RALEIGH PLANNING COMMISSION CERTIFIED RECOMMENDATION

CASE INFORMATION: Z-28-18 CABARRUS ST PD (MP-2-18)

COMPREHENSIVE PLAN AMENDMENT ANALYSIS – CASE Z-28-18 (MP-2-18)

Z-28-18: Required Amendment to the Future Land Use Map

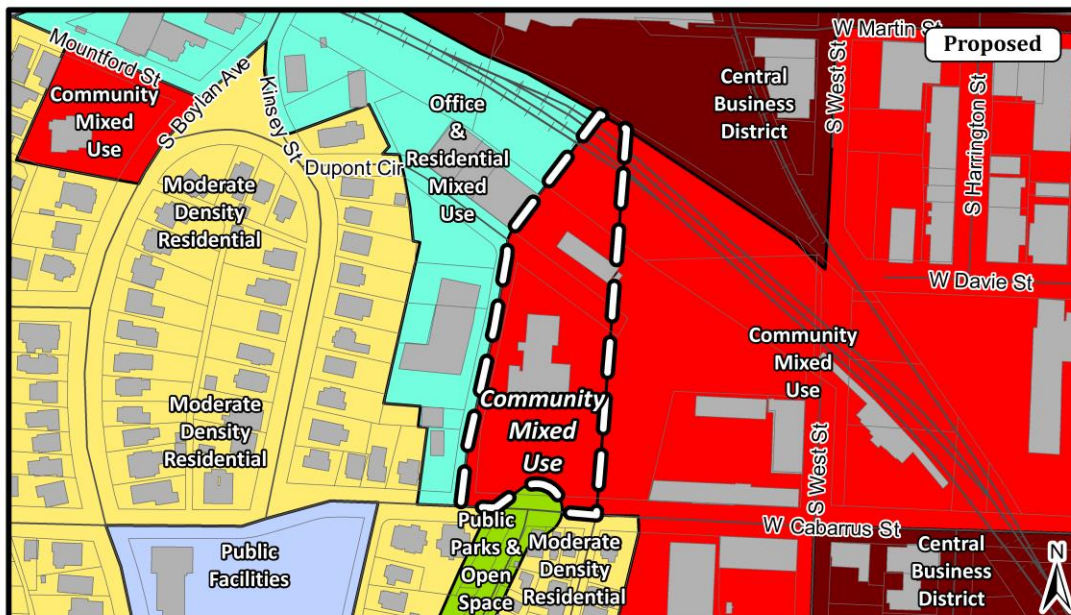
The uses permitted are consistent with the FLUM designation and the requested building height is inconsistent with Table LU-2 and the Downtown West Gateway Plan, the permitted building height can be reduced to mitigate FLUM inconsistency for this portion of the site.

The land uses permitted in Tracts 2 and 3 are inconsistent with the FLUM and inconsistent with Table LU-2, and the land uses permitted in Tract 1 are consistent with the FLUM and inconsistent with LU-2 and the Downtown West Gateway Plan. This renders the request inconsistent with the Future Land Use Map. This inconsistency can be addressed with a combination of limiting retail use in Tracts 2 and 3 and reducing height in Tracts 1, 2, and 3.

P-2

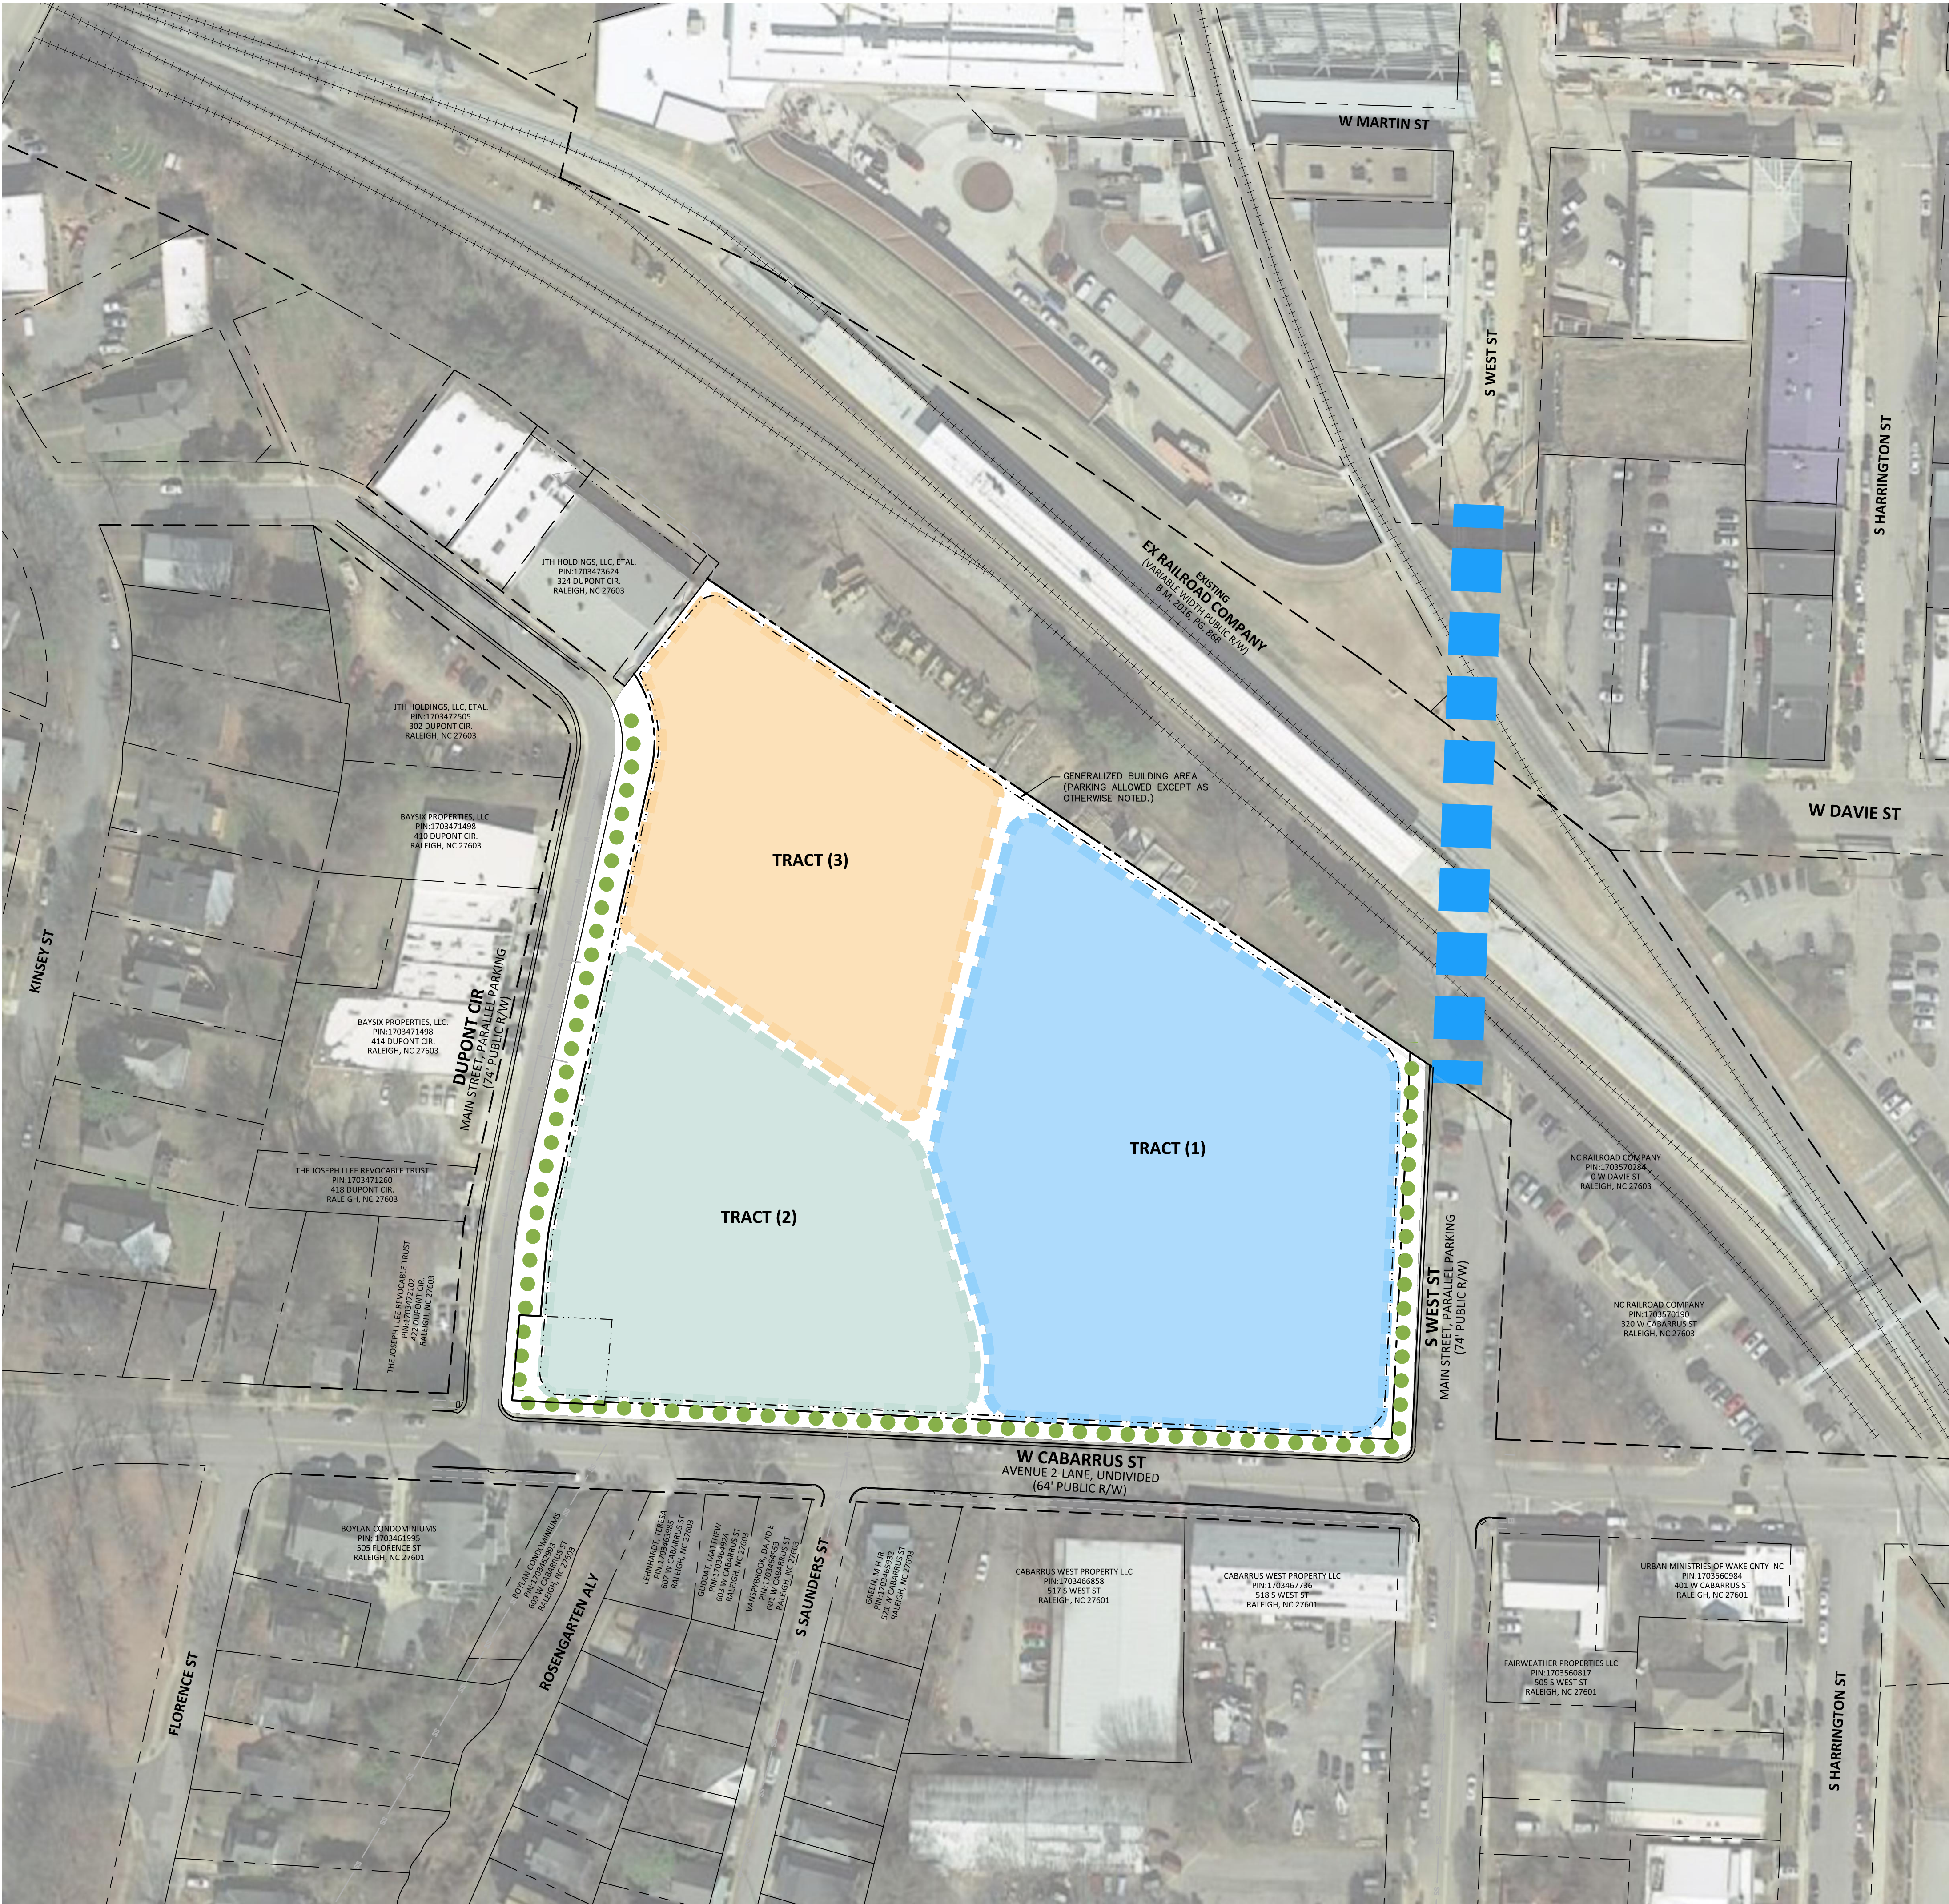
- While the proposed PD specifies standard street cross sections for Cabarrus Street, West Street, and Dupont Circle, it also states that they may be altered at the time of permitting with no limitation or detail. Therefore, impacts are unquantifiable.

- The proposed PD states that block perimeter standards will be met with the existing streets in the area. This means that the new development will not include new public streets which would otherwise be required. This modification negatively impacts connectivity.
- The proposed PD states that a pedestrian connection will be constructed between Dupont Circle and West Street. While this will improve connectivity through the site, no design, size, location, orientation or any other specification is provided. The plan simply states that a connection will be provided. More specification should be included in the PD.

The master plan narrative section 6 states that “a pedestrian connection shall be made through the development between Dupont Circle and S. West Street.” This statement does not communicate a dimension standard, route, location, or level of public access and therefore cannot be understood to provide a public benefit. Additionally, the Illustrative 3D Massing Study (plan sheet P-7) indicates a building massing that does not support an appropriate pedestrian connection that provides a public benefit. The only possible location is between the railroad right-of-way and the back side of the parking garage. This would place pedestrians at the least visible and central location of the site and does not provide a path visible from the outside.

Outstanding Issues		Suggested Mitigation	
	<ol style="list-style-type: none"> 1. Substandard curb cut alignment with S. Saunders Street. <i>See analysis for policy inconsistency related to pedestrian oriented development.</i> 2. Streetscape modification proposed in Master Plan Section 8.A has uncertain impact due to open ended nature of the proposed modification. 3. Floor plate size and building massing modifications in Master Plan Section 8.D and 8.E increase the maximum floor plate area above 12 stories and remove all other building massing standards. The intent of the PD district is to improve design quality. It is unclear how removing all building massing standards improves design quality. 4. The applicability of the Parking Setback standard in Master Plan Section 8.I.i. is unclear. 		<ol style="list-style-type: none"> 1. Specificity of driveway alignment either separated to the full 200' required by the UDO or aligned with South Saunders street should be made to address this safety issue. If alignment to these standards cannot be met or is otherwise undesirable by the applicant, other significant and essential pedestrian safety measures are necessary to mitigate this risk. 2. Greater detail or extent of should be provided to more accurately quantify the modification. 3. Specify building massing standards or other design detail that provides better design quality. 4. Revise Master Plan Section 8.I.i to add clarity or remove.
